# Comment Record Report For Reopened Phase 2 Scoping Period

August 18, 2016

# Proposed Bypass Routes

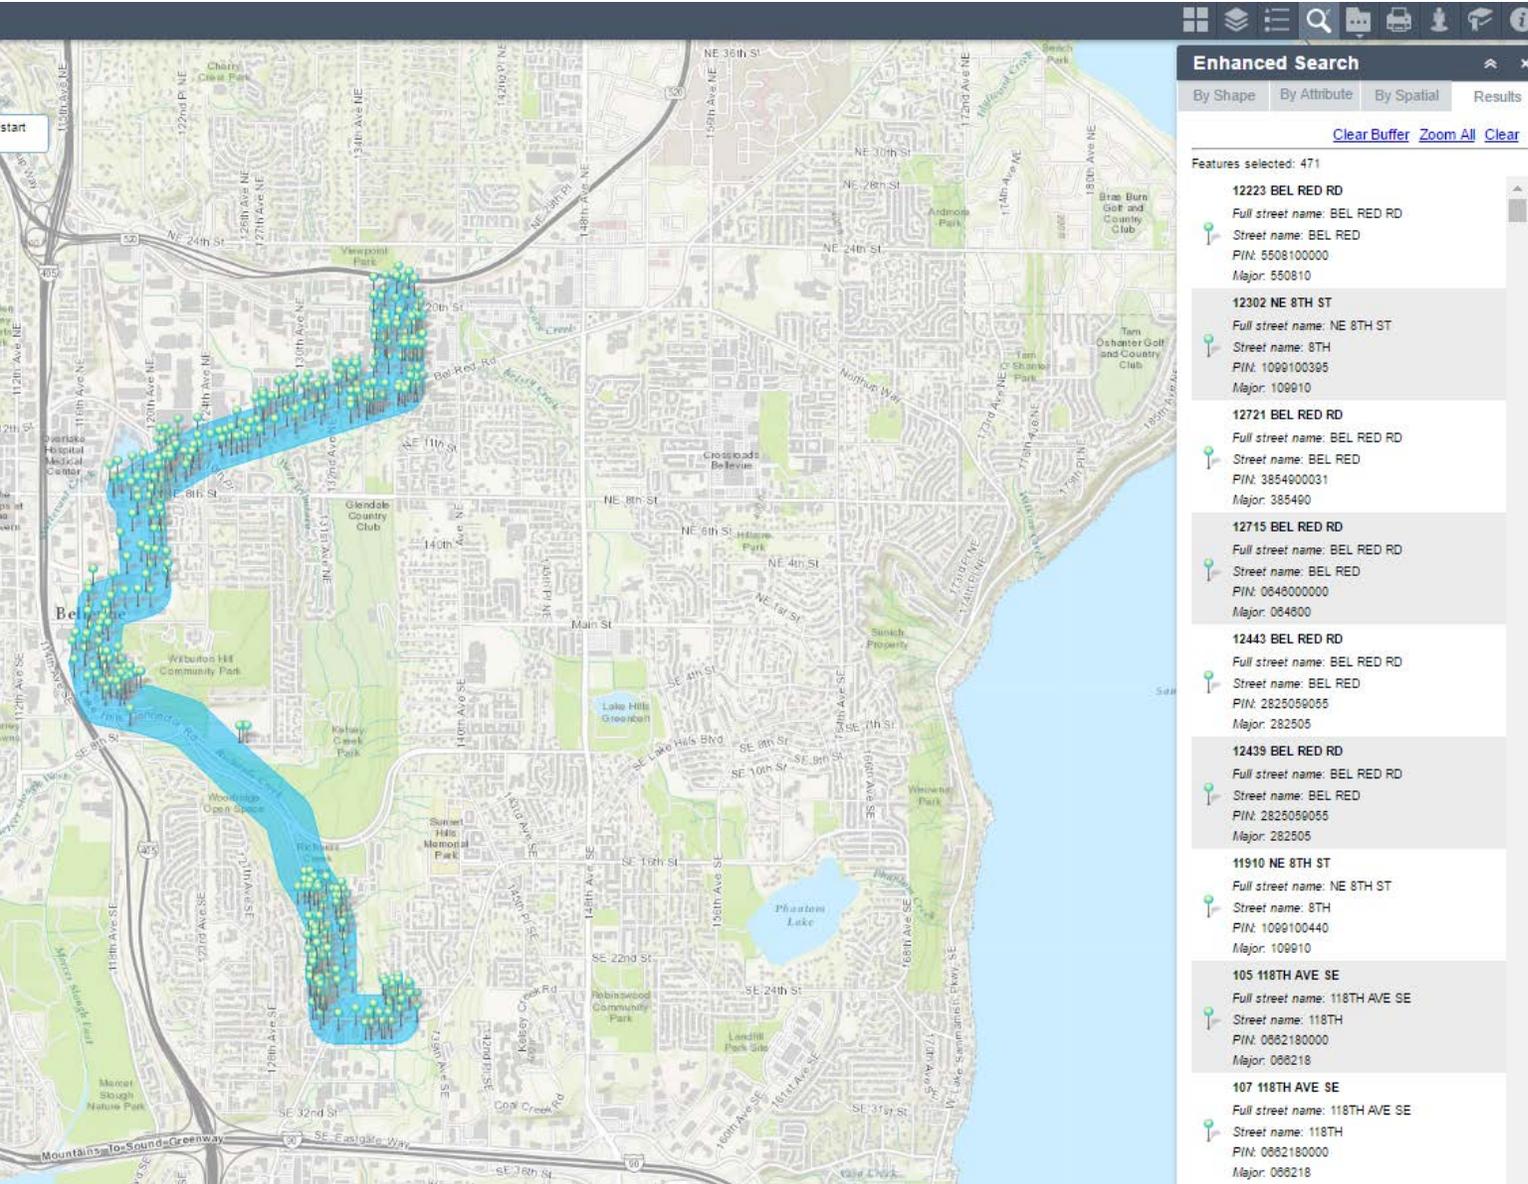
There are 333 addresses within 500' of this route with many of the addresses clustered near the North and South terminus where the impact is not really changed by the route location.

Contrast that with the Bypass Route 2 which with 470 addresses within the same 500' distance (40% more addresses).

But even these numbers severely undercount the impact of this route for two reasons:

- The majority of the addresses in the middle section are either apartments or office buildings and so house dramatically more people than addresses on the original route which are predominantly detached homes.
- The topography makes the Bypass Route directly visible to downtown residents looking West and members of the Wilburton and Woodridge neighborhoods looking North and East.

## GLENDALE COUNTRY CLUB

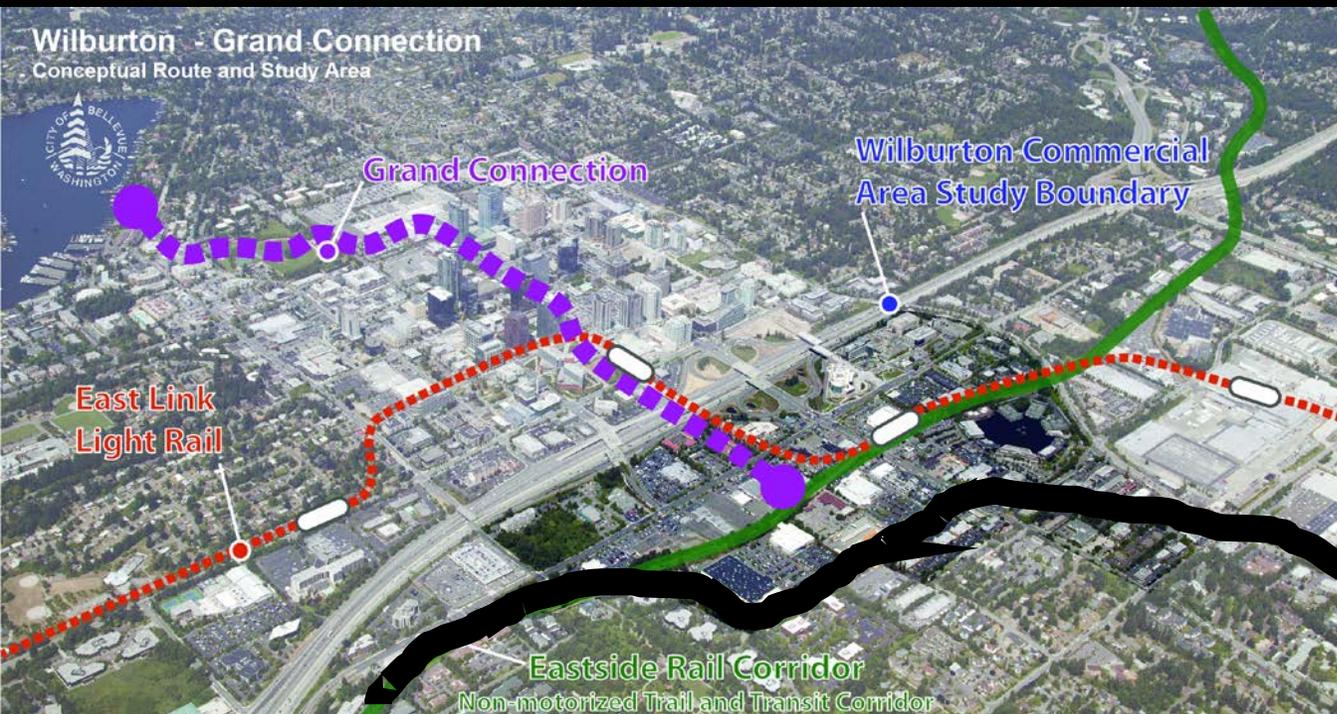
# Community Assets impacted

When you look at the community assets that would be impacted you can see why the original route was chosen.
